VOLLMER ROAD (BARBARICK) - INTERIM CONDITION

STREET IMPROVEMENT PLAN

JULY 2023

COVER SHEET

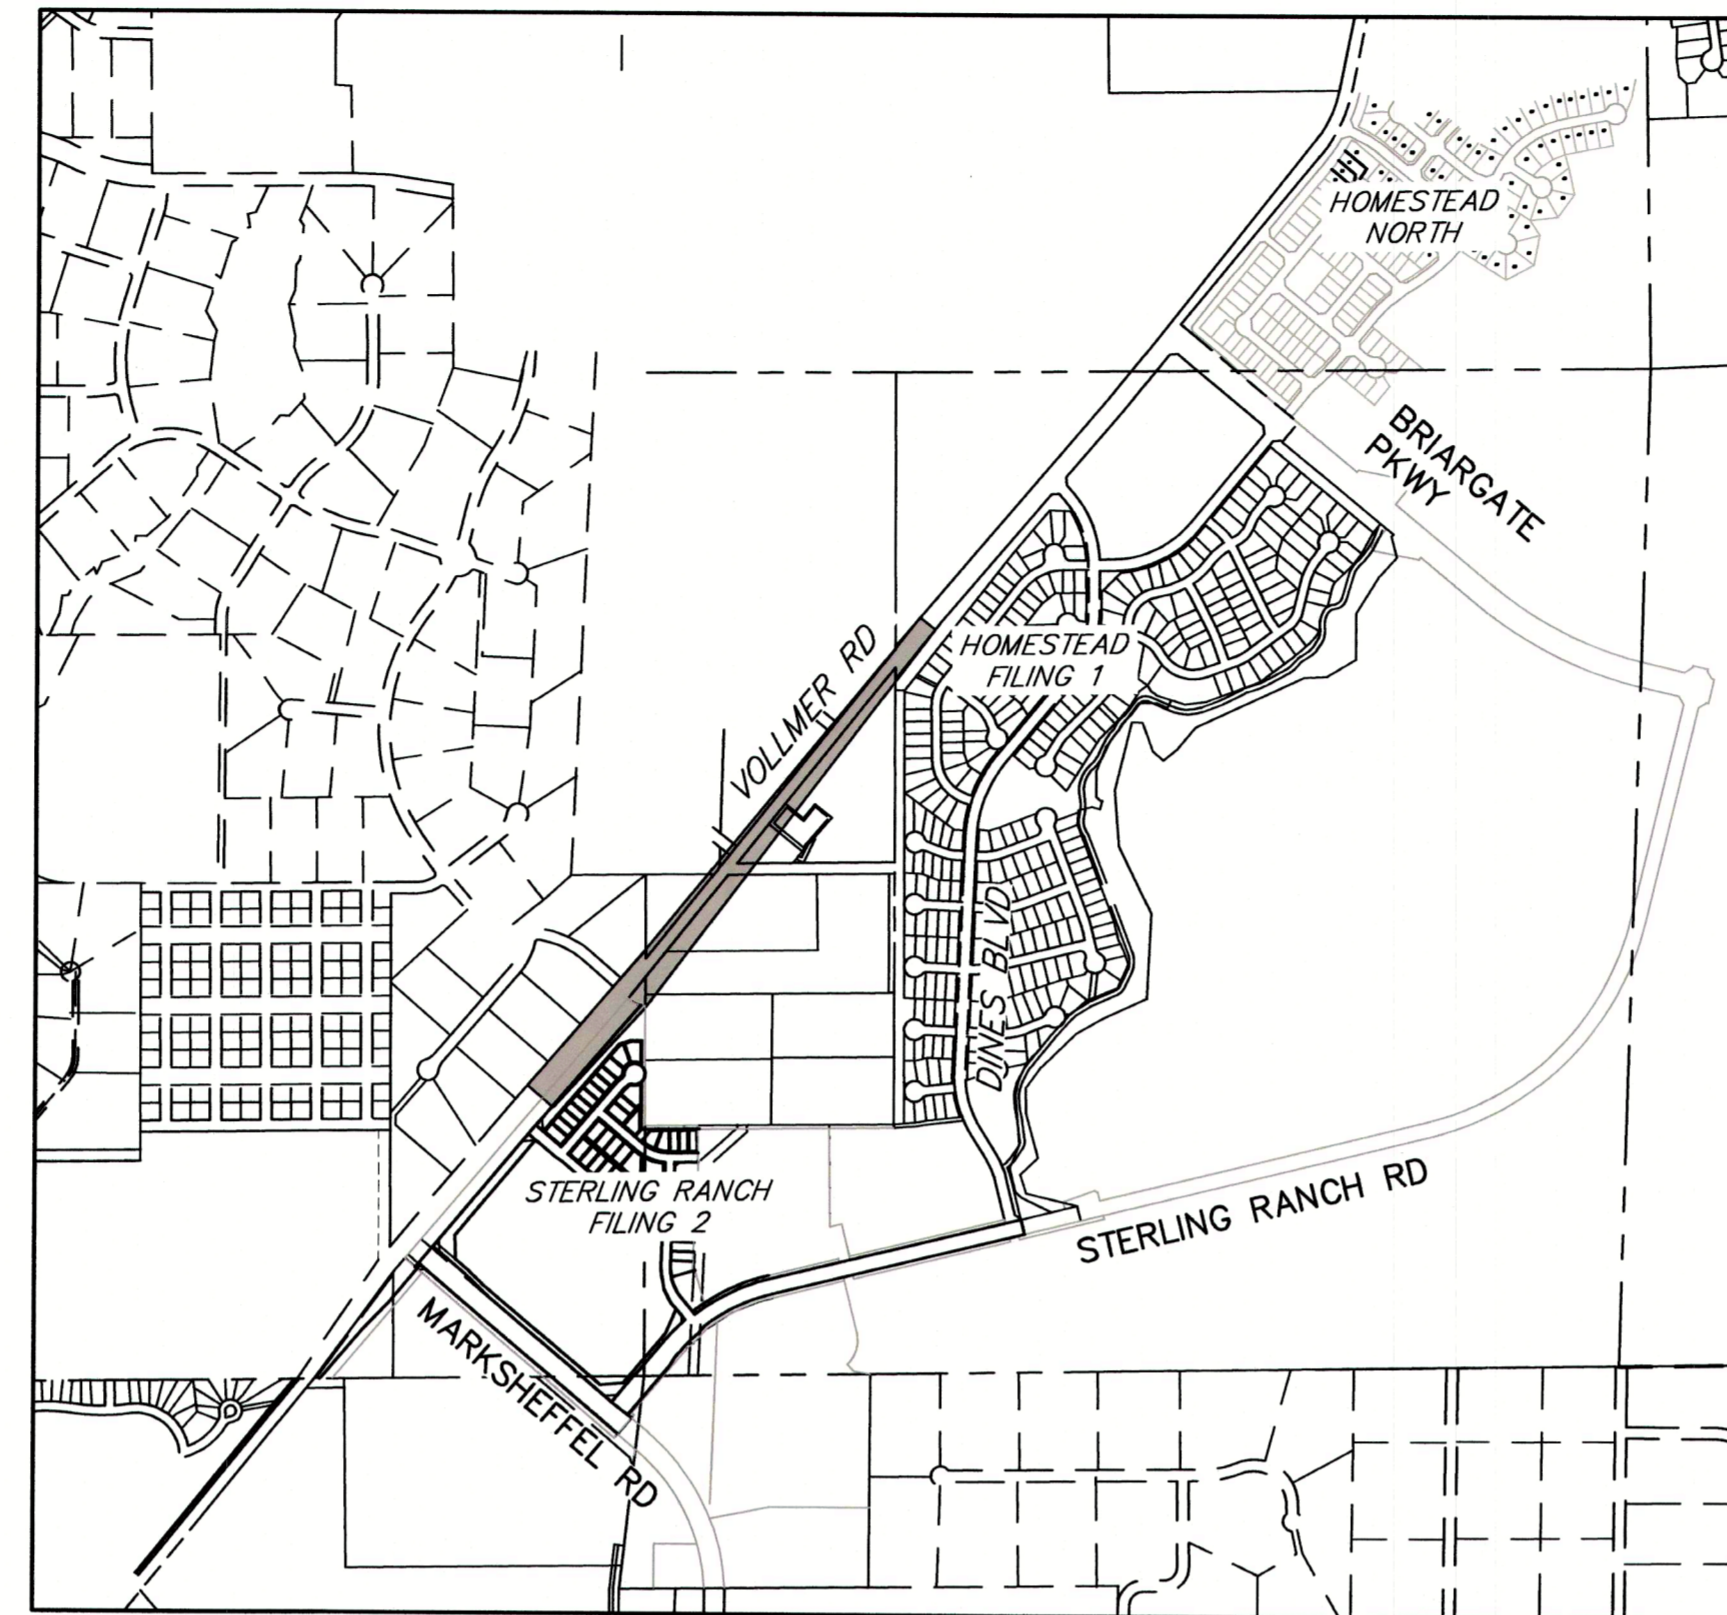
These plans should be for the construction of the interim condition, not only for information.

VOLLMER ROAD (INTERIM BARBARICK SECTION)
MODIFIED RURAL MINOR ARTERIAL CROSS SECTION
SCALE: NTS

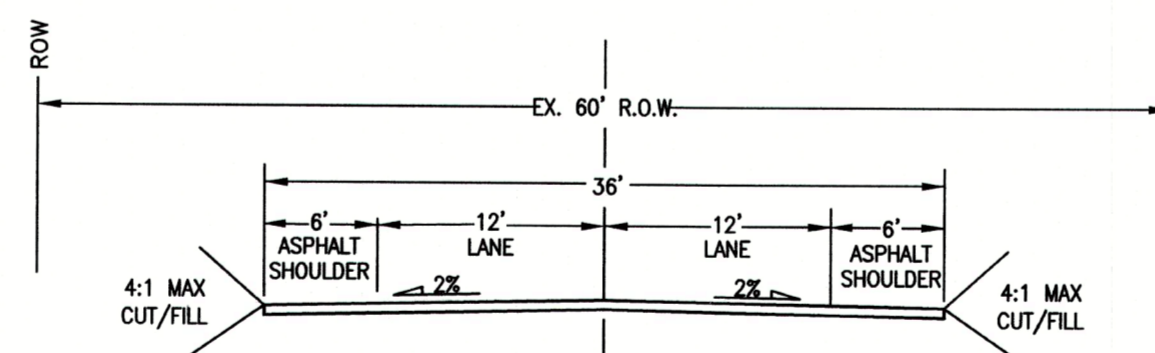
The interim cross section should show the existing roadway and the proposed widening section clearly distinguished.
